Access Compliance Report Public Rights-of-Way (Curb Ramps)

Main Street: DODGE_AVE Cross Street: WOODGLEN_DR Location: NW

ADA ID: RPAT211018120409 Ramp Type: Type 1 - Perpendicular Initial Pass/Fail: Fail Overall Compliance: No Severity Score: 15

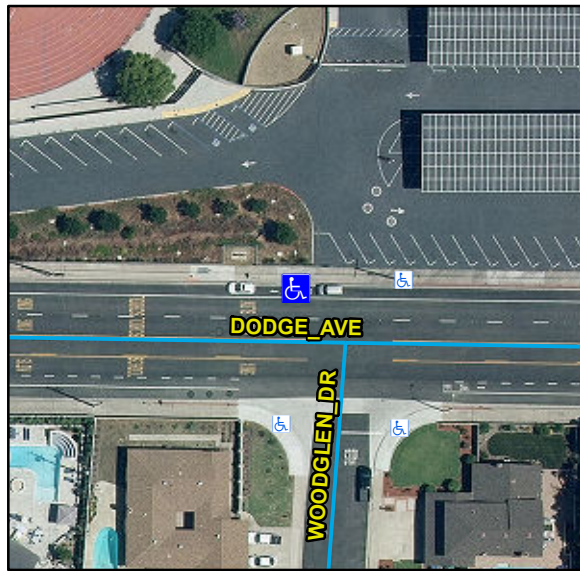
Compliance	Description	Data	Compliance	Description	Data
N/A	Ramp Length (in)	47	N/A	Flare Type LT	
Yes	Ramp Width (in)	51			N/A
No	Ramp Run Slope (%)	8.6	N/A	Flare Slope LT (%)	N/A
Yes	Ramp Cross Slope (%)	1.6	N/A	Flare Traversable LT	N/A
N/A	Landing Present	N/A	N/A	Flare Type RT	
N/A	Landing Length (in)	N/A			N/A
N/A	Landing Width (in)	N/A	N/A	Flare Slope RT (%)	N/A
N/A	Landing Run Slope (%)	N/A	N/A	Flare Traversable RT	N/A
N/A	Landing Cross Slope (%)	N/A	N/A	DWS Provided	N/A
N/A	Landing Movement Obstructed?	N/A	N/A	DWS Contrast	N/A
	Landing Movement Type	N/A	N/A	DWS Length (in)	N/A
N/A	Landing Shared	N/A	N/A	DWS Full Width	N/A
N/A	Clear Space	N/A	N/A	DWS Offset Left (in)	N/A
N/A	Clear Space To Crosswalk (in)	N/A	N/A	DWS Offset Right (in)	N/A
N/A	Marked Crosswalk 1	No	N/A	Marked Crosswalk 2	N/A
	Crossing 1 Direction	S		Crossing 2 Direction	N/A
	Marked Crosswalk 1 Width (in)	N/A		Marked Crosswalk 2 Width (in)	N/A

Remove & Replace Entire Ramp.
